SUNDRY NOTICES AND REPORTS ON WELLS	
Do not use this form for proposals to drill or to re-enter an	
abandoned well. Use Form 3160-3 (APD) for such proposals	5.

/			
SUBMIT IN TRIPLICATE – Other instructions on page 2.			7. If Unit of CA/Agree	ment, Name and/or No.	
I. Type of Well				- IN/A	
Oil Well Gas W	Vell Other			8 Well Name and No Ruby Federal #11

2. Name of Operator ConocoPhillips Company		.,		9. API Well No. 30-025-40522	
Ba, Address		3b. Phone No. (include area co	ode)	10. Field and Pool or E	Exploratory Area
PO Box 51810 Midland, TX 79710-1810		432,688-6913		Maljamar; Yeso Wes	st

Drilling has opted to contract for a different rig to drill this well. The KB elevation for the new rig is one (1) foot less than the previous rig. The new KB elevation is 13 feet. No additional changes to the approved plan is anticipated at this time. Enclosed are four (4) documents supporting this approval request for our plan change. These are:

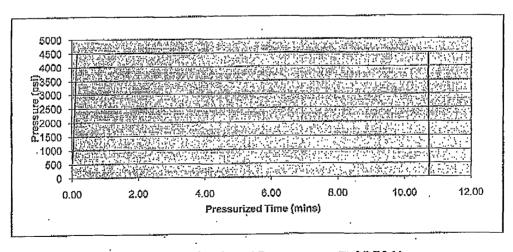
Variance approved to use flex line from BOP to choke manifold. Check condition of flexible line from BOP to choke manifold, replace if exterior is damaged or if line fails test. Line to be as straight as possible with no hard bends and is to be anchored according to Manufacturer's requirements. The flexible hose can be exchanged with a hose of equal size and equal or greater pressure rating. Anchor requirements, specification sheet and hydrostatic pressure test certification matching the hose in service, to be onsite for review. If the BLM inspector questions the straightness of the hose, a BLM engineer will be contacted and will review in the field or via picture supplied by inspector to determine if changes are required (operator shall expect delays if this occurs).
